JOSEPH M. FARLEY NUCLEAR PLANT, UNIT NO. 2

Amendment No. 55  
License No. NPF-8

AMENDMENT NO. 55 FACILITY OPERATING LICENSE NO. NPF-8

SAFETY EVALUATION BY THE OFFICE OF NUCLEAR REACTOR REGULATION  
RELATED TO AMENDMENT NO. 55 TO FACILITY OPERATING LICENSE NO. NPF-8  
ALABAMA POWER COMPANY  
JOSEPH M. FARLEY NUCLEAR PLANT, UNIT NO. 2  
DOCKET NO. 50-364

FIGURE 3.4-2 FARLEY UNIT 2 REACTOR COOLANT SYSTEM HEATUP LIMITATIONS APPLICABLE FOR THE FIRST 8 EFPY

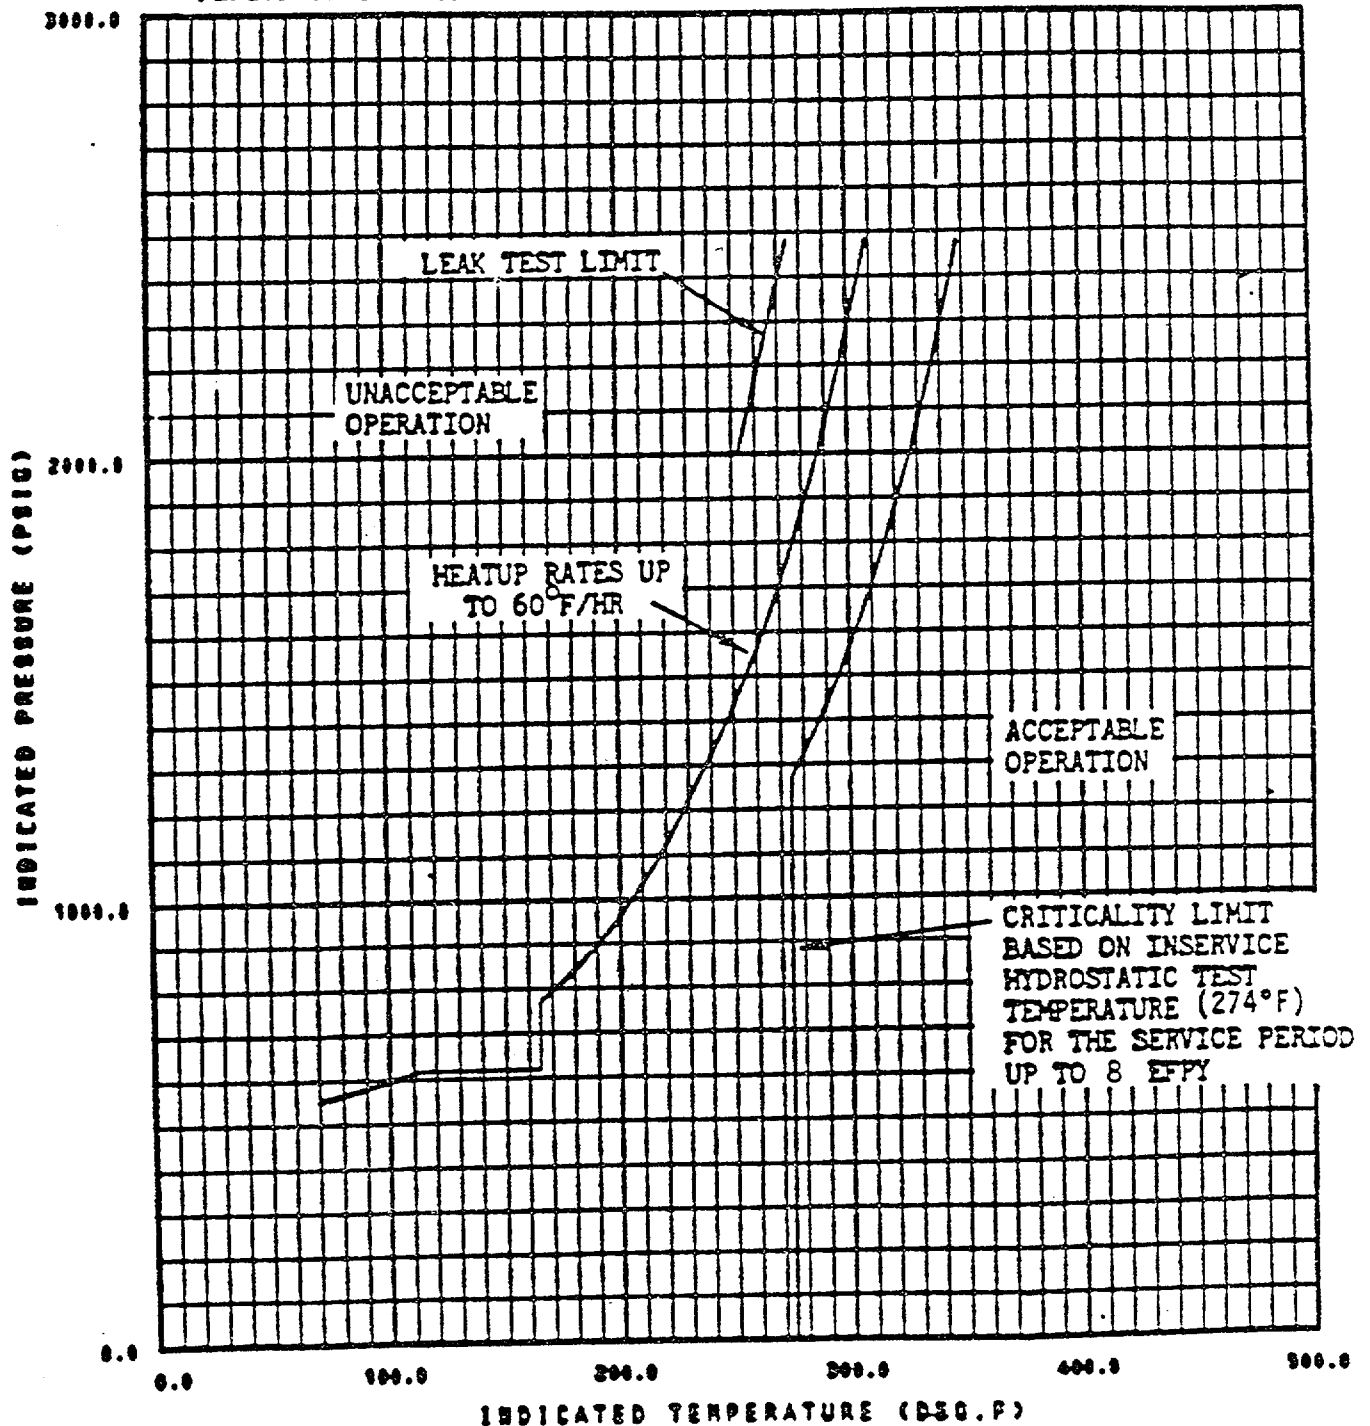
The amendment modifies Technical Specifications Table 4.4-5 and Figures 3.4-2 and 3.4-3 based on results of analysis of Capsule "U" Reactor Vessel Surveillance Program. Changes are in accordance with 10 CFR 50 Appendix G and H and are acceptable for eight effective full power years of operation.

In a letter from R. P. McDonald to S. A. Varga dated September 30, 1985, Alabama Power Company (the licensee, APCo) requested changes to the Joseph M. Farley Nuclear Plant, Unit 2 heatup/cooldown curves and supporting bases. The curves and bases are contained in Figures 3.4-2 and 3.4-3 and Bases Section 3/4.4.10 of the Farley 2 Technical Specifications. The effect of neutron irradiation on the Farley 2 reactor vessel beltline materials is documented in Westinghouse Report WCAP-10910, which is enclosed in the licensee's letter of September 30, 1985. The effect of boltup, pressure and thermal stresses on the reactor vessel closure flange region is documented in Attachment 2 to the licensee's letter of September 30, 1985 and in a previous letter from R. P. McDonald to S. A. Varga dated June 18, 1984. By letter dated March 27, 1986, APCo provided supplementary information following discussions with the NRC staff. Our discussion and evaluation follows.

The licensee's submittal of September 30, 1985, includes a bases section and figures showing the proposed pressure/temperature limits. The pressure/temperature limits are proposed for nine EFPY. But, our review shows that the licensee's proposed calculation method does not include sufficient margin to account for neutron irradiation damage. Hence, the proposed bases section required revision. Also, the proposed heatup/cooldown curves would meet the safety margins of Appendix G of the ASME Code Section III for only 8.0 EFPY instead of the proposed 9.0 EFPY. For these reasons, we advised the licensee and Westinghouse of our evaluation during various telecons. As a result, by letter dated March 27, 1986, the licensee modified their earlier bases section and provided heatup/cooldown curves for 8.0 EFPY which are acceptable.

Based on our review and on the above two conclusions, we conclude that the modified heatup/cool-down curves provided in licensee letter dated March 27, 1986, meet the safety margins of Appendix G, 10 CFR 50 and are acceptable for eight EFPY of operation.
